Mandatory Bulletin No BO-11/98 MDM 1-FOX**Concerns:**

Additional inspection of aileron-drive fitting.

Zakład Remontów i Produkcji Sprzętu Lotniczego
Edward Margański _ Bielsko-Biala

item 3, Fig. 6 of „Technical Service Manual” (Issue III and Issue II)

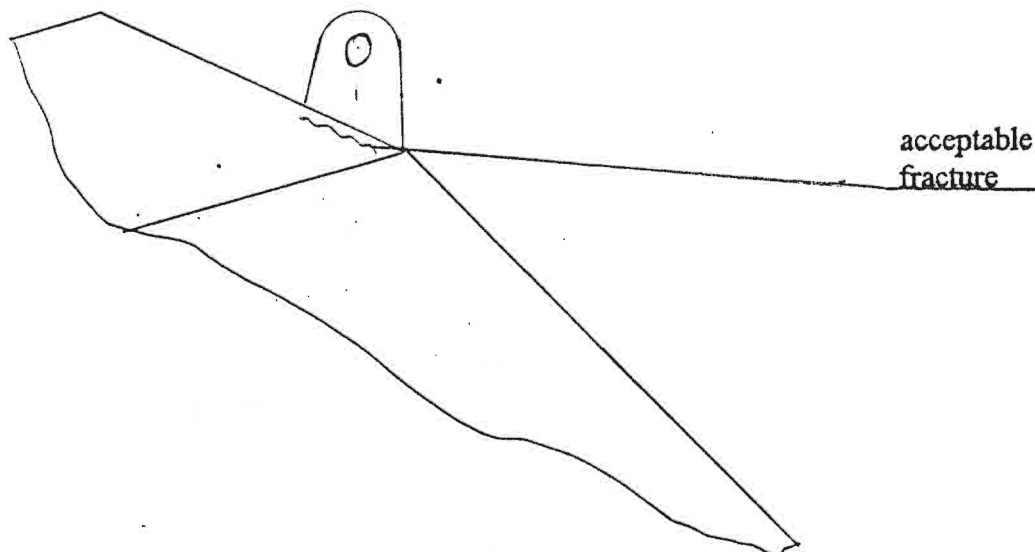
- a) after previous cleaning off the lacquer, check aileron-drive fitting (metal part) against fractures in the areas indicated on the drawing, use magnifying-glass of at least x5,

- b) after inspection secure cleaned elements against corrosion with a transparent epoxy lacquer (next inspection will then not require cleaning the fittings),
- c) record executing the inspection in glider's log book,
- d) after eventual identification of fractures, notify immediately the glider's producer sending an appropriate photographic and descriptive documentation,
- e) in this case the glider is grounded until the identified defects are removed,

- f) fractures to lacquer and these to underlying thickened resin at fitting - aileron connection are acceptable,
